## **163 Iverson Road – Review of Facade Specification**

I have reviewed the noise survey data and proposed facade specification in the Sol Acoustic report ref P1498-REP01-SJF dated 27 June 2013. We have also analysed the spreadsheet of their raw survey results supplied in addition to the report.

## **163 Iverson Road – Review of Facade Specification**

## Planning Report

**Figure 1** – Maximum Levels from Sol Noise Survey (night time)

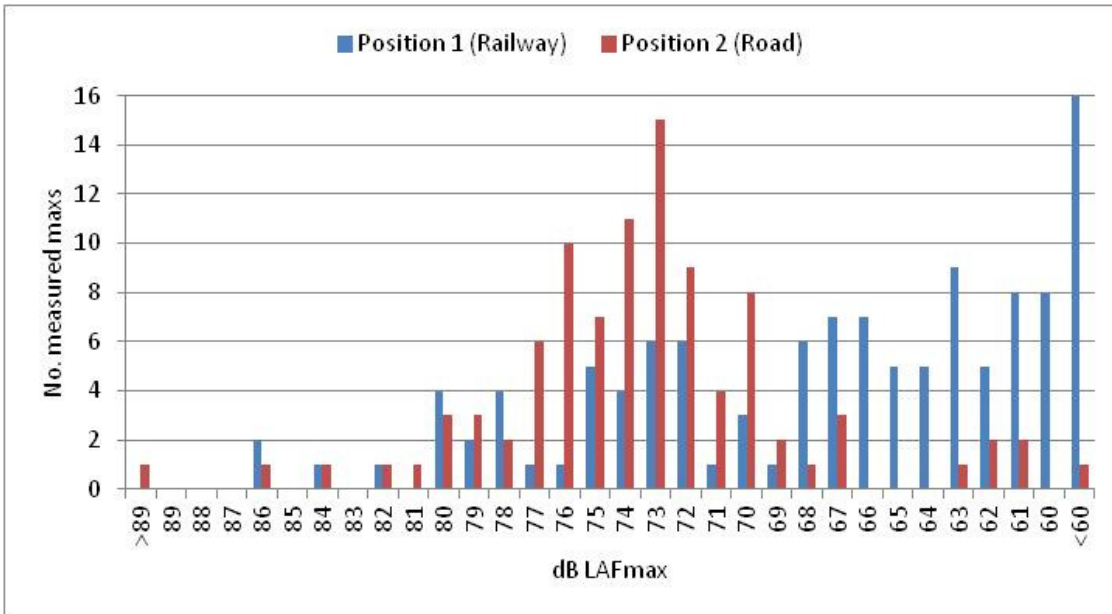
To determine the typical external maximum noise level I have disregarded the 10 highest maximum noise levels measured and taken the remaining highest level as typical. This is in line with the WHO guidance that 10-15 occurrences are acceptable. With reference to the graph above, the typical external maxima are taken as:

I note that more than 1 maximum level will have occurred within the 1 minute or 5 minute period of measurement used by Sol. Therefore we have allowed for 10 of the highest measurements to be discarded rather than 15 (as is acceptable within WHO guidelines) to allow for potential additional maxima within a measurement period. Therefore our choice of typical maximum levels is robust. It is clear from Figure 1 that for both facades the vast majority of maximum noise events are lower than the levels in Table 1.

Position 1 (railway facade)	78 dB $L_{AFmax}$
Position 2 (Iverson Rd facade)	79 dB $L_{AFmax}$

**Figure 1** – Maximum Levels from Sol Noise Survey (night time)

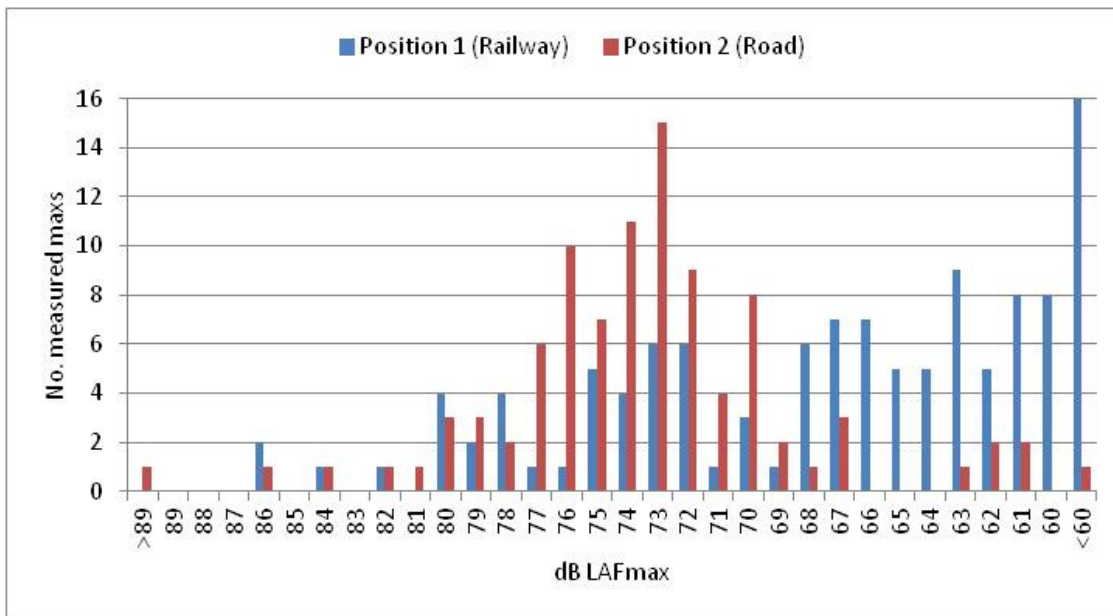
It is clear that the highest maximum levels recorded, shown in Tables 1 and 2 above, are a small percentage of the total number of maximum levels and the distribution of maxima in Figure 1 shows that the vast majority are significantly lower.

**Appendix A** – Diagram showing barrier corrections taken from Calculation of Rail Noise 1995

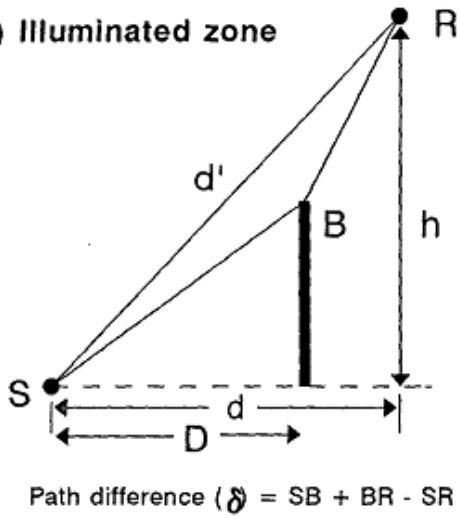
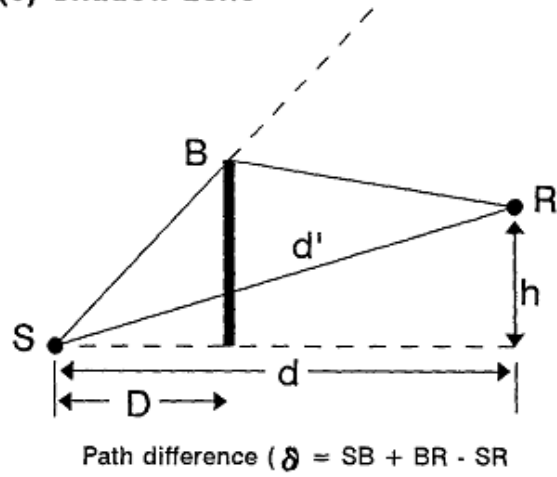
This is not the case. A barrier will offer a reduction in noise level within its “Shadow Zone” and can also provide some reduction in level within its “Illuminated Zone” (see diagram in Appendix A). Outside of these zones, the barrier will have no effect on the sound propagating from the source.

Note that Chart 6(a)(ii) of Calculation of Railway Noise (HMSO) shows that for the illuminated zone, where the path difference is greater than 0.4m, the correction is zero. This is the case for the facade areas of the first floor and above of the Iverson Road building which the barrier will have no effect upon.

The gardens would be in the “shadow zone” and the barrier correction would be approximately 8dB. Based on a daytime noise level of 65.9dB  $L_{Aeq,16hour}$ , at Position 1 of the Sol report, the level in the gardens would be approximately 58dB  $L_{Aeq,16hour}$ .
